The Commission has issued the enclosed Amendment Nos. 45 and 28 to Facility Operating License Nos. NPF-4 and NPF-7 for the North Anna Power Station, Unit Nos. 1 and 2 (NA-1&2). The amendments are effective as of the date of issuance.

The changes amend the NA-1&2 TS based on your reanalysis of the LOCA-ECCS performance assuming seven (7) percent steam generator tube plugging. These changes revise the heat flux hot channel factor, F_Q , from 2.14 to 2.20.

Amendment No. 45
License No. NPF-4

SUPPORTING AMENDMENT NOS. 45 AND 28 TO
FACILITY OPERATING LICENSE NOS. NPF-4 AND NPF-7
VIRGINIA ELECTRIC AND POWER COMPANY
NORTH ANNA POWER STATION, UNIT NOS. 1 AND 2
DOCKET NOS. 50-338 AND 50-339

Figure 3.2-2 $K(Z)$ - Normalized $F_Q(Z)$ as a Function of Core Height

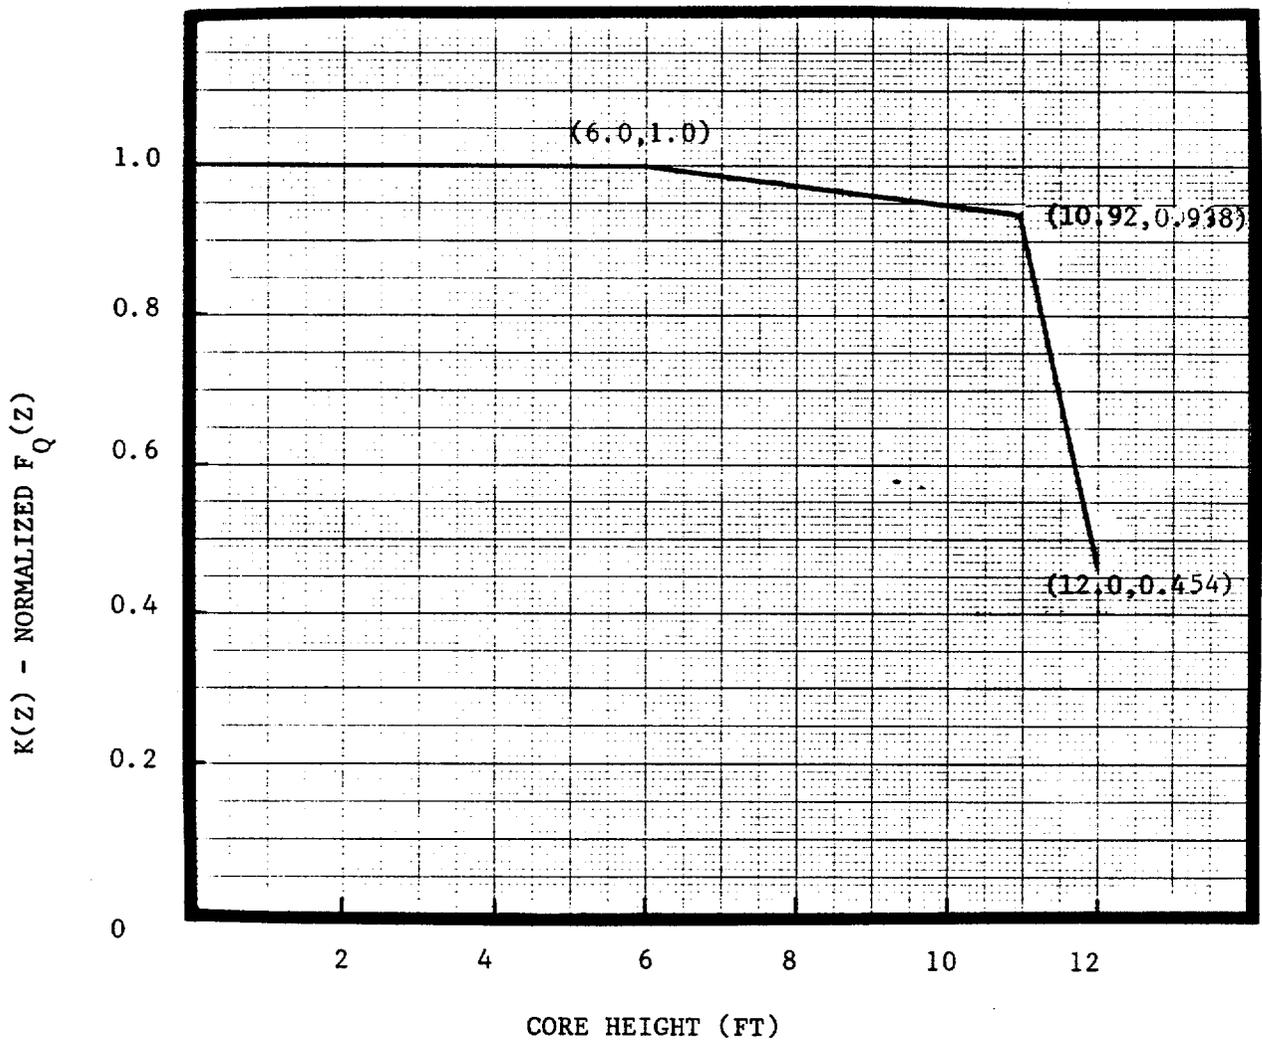
The results of the licensee's LOCA-ECCS reanalysis supports a new F_0 limit of 2.20. We have reviewed the TS changes due to changing F_0 from 2.14 to 2.20. As part of this change, a new $K(Z)$ curve was generated in Figure 3.2-2 of the NA-1&2 TS. We have independently verified the accuracy of the curve by recalculation using Westinghouse methodology. Our calculations show that the $K(Z)$ curve as submitted by the licensee is correct.

$$F_Q(Z) \leq \frac{[2.20]}{P} [K(Z)] \text{ for } P > 0.5$$

$$F_Q(Z) \leq [4.40] [K(Z)] \text{ for } P \leq 0.5$$
